**TO:** Design Review Commission  
**FROM:** Sean K. Gallegos, Assistant Planner  
**SUBJECT:** 13-SC-16 – 767 Santa Rita Avenue

Consider the revised design review application 13-SC-16 subject to the listed findings and conditions

13-SC-16—767 Santa Rita Avenue

**A1.2**  
 DETAILED FLOOR PLAN

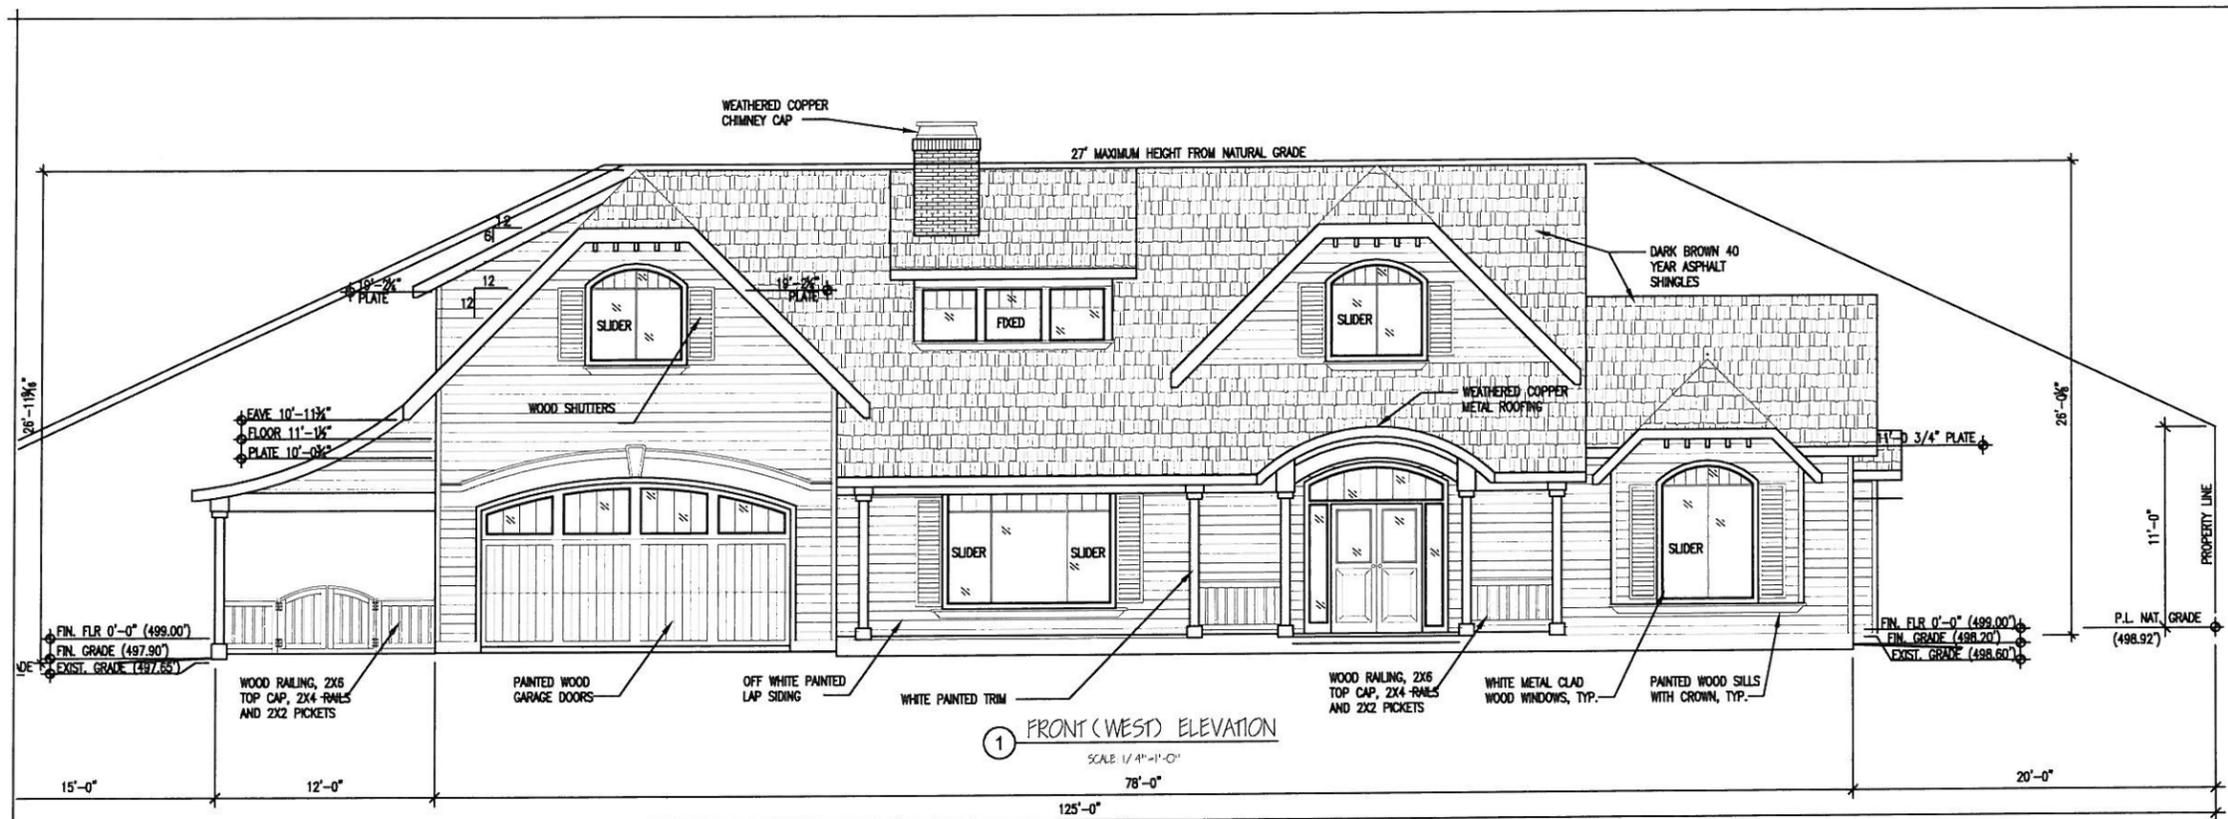
- Re-consider window design and reduce the privacy impacts toward the rear;
- Reduce bulk of the rear elevation; and
- Reduce the privacy impacts from the balcony.

To alleviate the privacy concerns, the large second story windows facing the rear yard were replaced with high-sill windows. In addition, the second story balcony has been lowered by nearly one foot, which creates a balcony recessed within the roof form and surrounded with solid walls, instead of an open railing. This design combined with a rear facing privacy railing of three feet, nine inches, and a side facing wing wall with a height of five foot, nine inches, effectively minimizes privacy impacts to the south and the east neighboring properties. In addition, the landscape plans has been modified to retain a redwood tree along the rear (east) property line and incorporates numerous screening plants along the north, south, and east property lines to mitigate additional privacy impacts.

3. REDUCE THE PRIVACY IMPACT FROM THE BALCONY. The deck level of the balcony has been lowered by almost a foot. Now, stepping out on to the balcony, there are two steps down. Note that the balcony is sunken into the roof providing solid wall (not open railing) privacy on all four sides, the lowest side being 3'9" high. Additionally, the landscape plan has been modified. In addition to the existing valley oak, which holds its leaves into December, the existing triple-trunked Redwood and the large trees in the neighboring yards, the perimeter of the property is slated for numerous conifers. At the two neighboring yards that may be seen from the balcony, the previously proposed trees have been replaced with dense, fast growing Singleleaf Pinyon (pine family) trees, 5-15 gallon size. See Landscape Plan L1.1.
